PPP-P-704E
AMENDMENT-2
February 20, 1987
SUPERSEDING
AMENDMENT-1
December 28, 1983

FEDERAL SPECIFICATION

PAILS, METAL: (SHIPPING, STEEL, 1 THROUGH 12 GALLONS)

This amendment, which forms part of Federal Specification PPP-P-704E, dated October 30, 1981, is approved by the Assistant Administrator, Office of Federal Supply and Services, General Services Administration for the use of all Federal agencies.

FIG 9 A PRESS-IN TYPE PLASTIC NOZZLE AND CAP CLOSURE WITH PLASTIC PUSH-PULL SPOUT

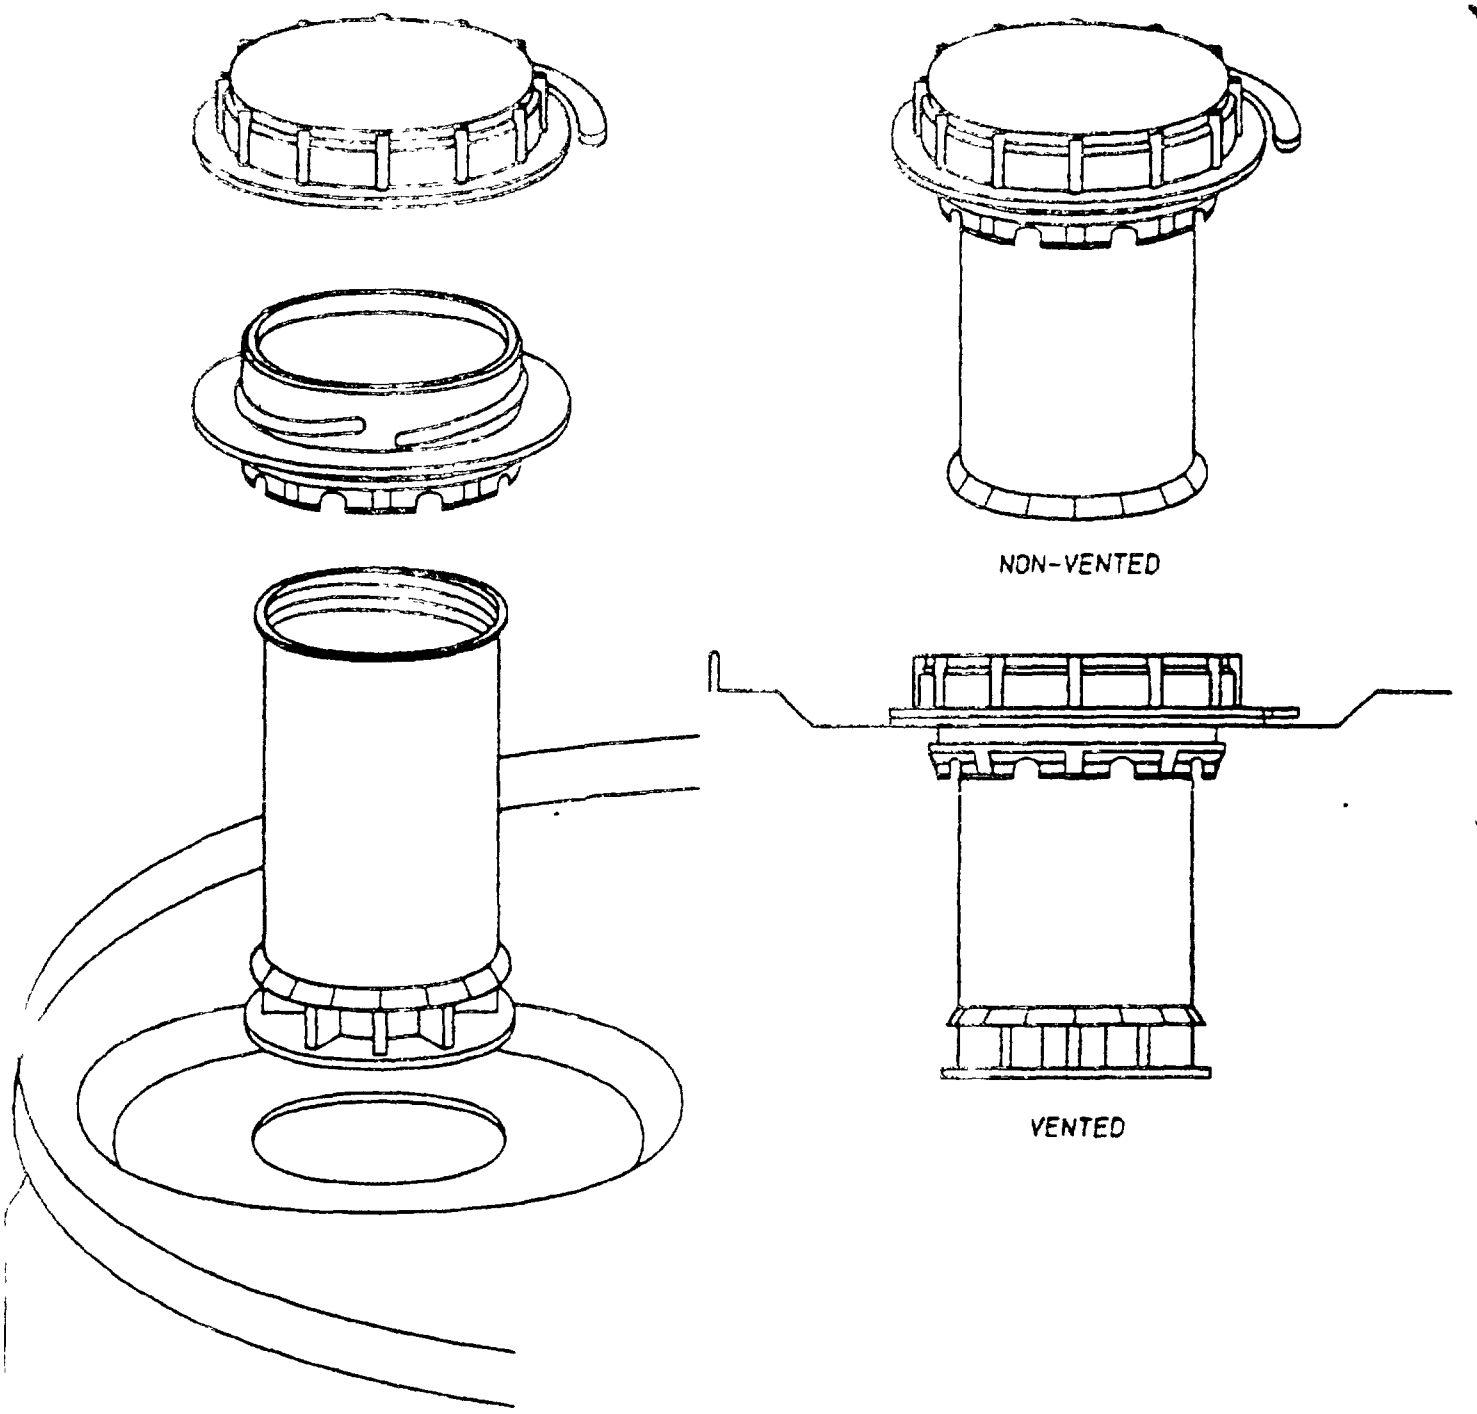
"3.1.4.1.1 Press-in pull-up closure with screw cap with integral tamper evident seal (see figure 9A). The press-in pull-up closure with screw cap with integral tamper evident seal shall be molded of commercial quality polyethylene or comparable functioning plastic. The closure shall be designed to be pressed into the opening in the pail top. The closure shall have the flanges of its neck and its cap fused together in such a way as to form a leak-proof and tamper evident seal. A pull-tab shall be provided on the cap flange for removal of the tamper evident seal. The closure shall have a pouring opening of not less than 1-1/2 inches in diameter. The closure shall include a pull-up pouring spout, either self-venting or non-venting (see 6.2), and molded of commercial quality polyethylene or comparable functioning plastic. The spout shall be able to be raised to fully extended pouring position after removal of the tamper evident seal by means of the screw-cap which is screwed into the pull-up spout. The spout, in extended pouring position, shall tightly engage within the nozzle opening."

Add new figure 9A (attached).

FIGURE 10 - COLLAPSABLE SPOUT

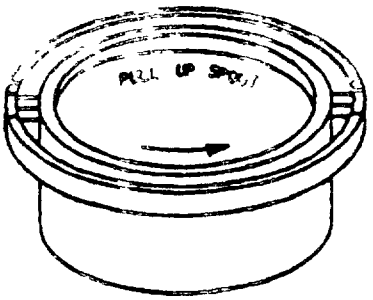
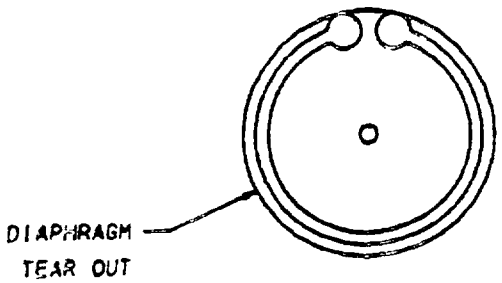
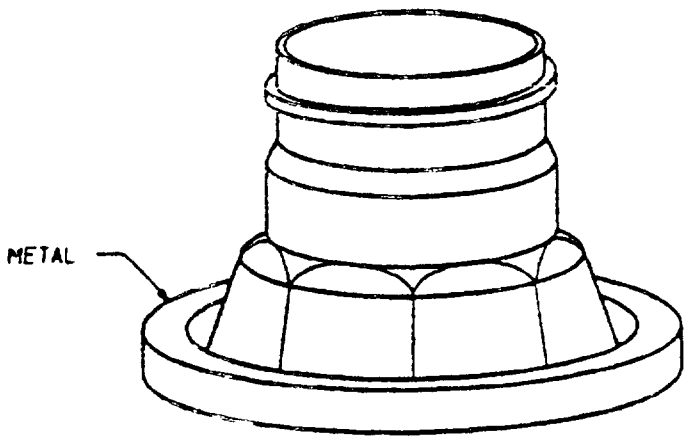
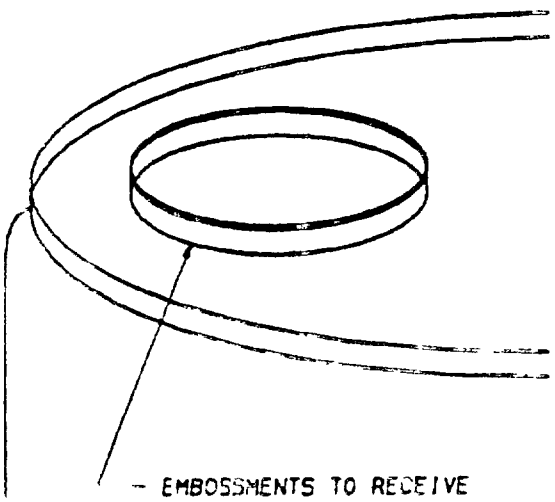
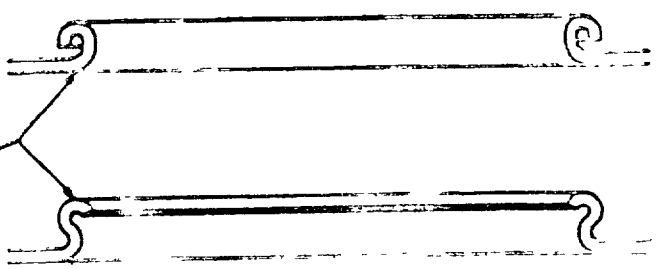
3.1.4.9.4, last line: Delete "(see figure 10)" and substitute "(see figures 10 and 20)".

Figure 10: Delete in entirety, add new figure 10 (attached).

"3.1.4.9.3 Collapsible spout closure. Collapsible spout closure shall be molded of commercial quality polyethylene or a comparable functioning plastic. A tear out diaphragm of the same material shall be molded as an intergal part of the pouring spout. The portion of the closure attached to the container shall be molded so as to fit on the outside diameter of the sealing portion of the preformed opening in the container head prior to being clinched. The preformed opening shall provide an opening in the container of approximately 2-3/8 inches to receive the collapsible spout closure. The pour spout shall be collapsed inward and shall be pliable so that it may be excended upward from collapsed position to pouring position. The pouring end of the spout shall have male threads and shall be fitted with a plastic screw cap made of polyethylene or comparable functioning material for reclosing. The plastic screw cap shall have one or two bails or other suitable finger grips for lifting the spout into a pouring position. The bails or finger grips shall be molded as an integral part of the cap (see figures 10 and 20)".

FIGURE 20 - COLLAPSIBLE SPOUTS

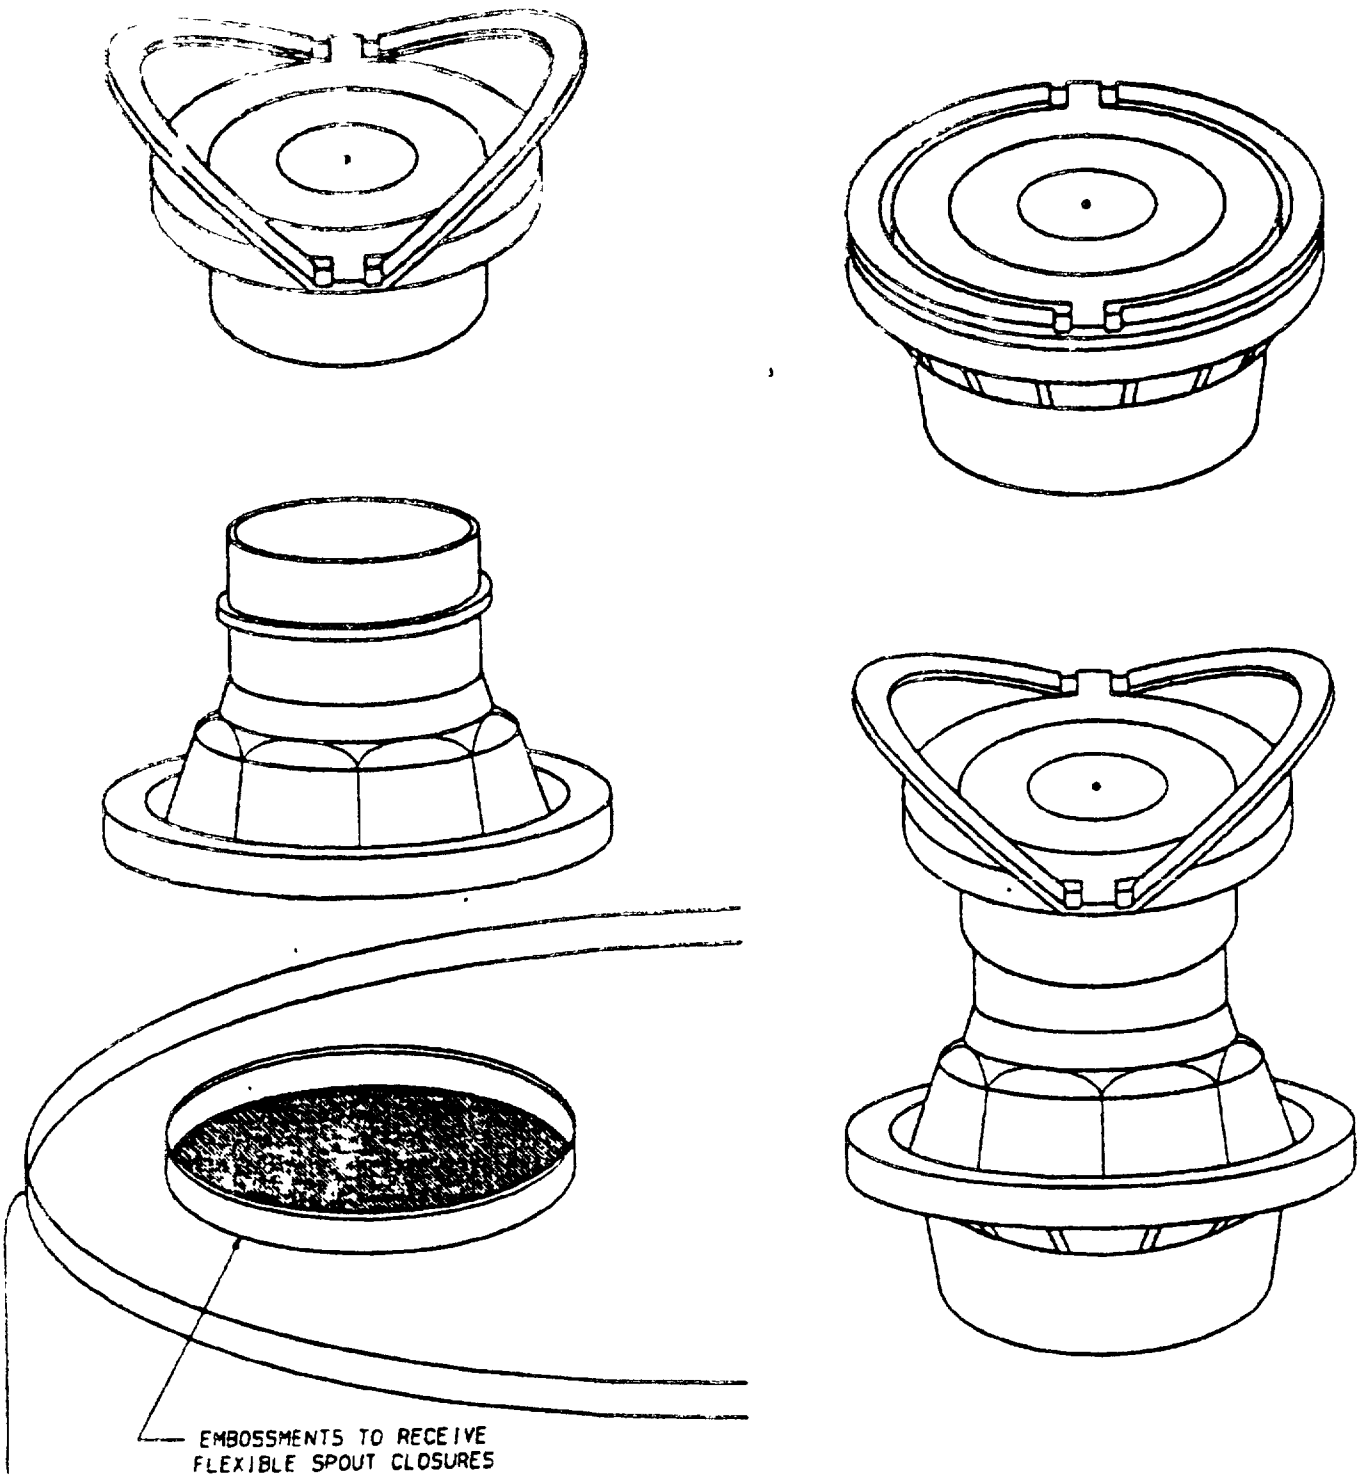
3.1.4.5, line 2: Delete "18" and substitute "20".
line 20: Delete "flexible" and substitute "collapsible".
line 20 after "figure 10": add "and 20".
line 21: Delete ", and 18".

3.1.4.8, line 4: Delete "and 14" and substitute "14, and 20".

Add new figure 20 (attached).
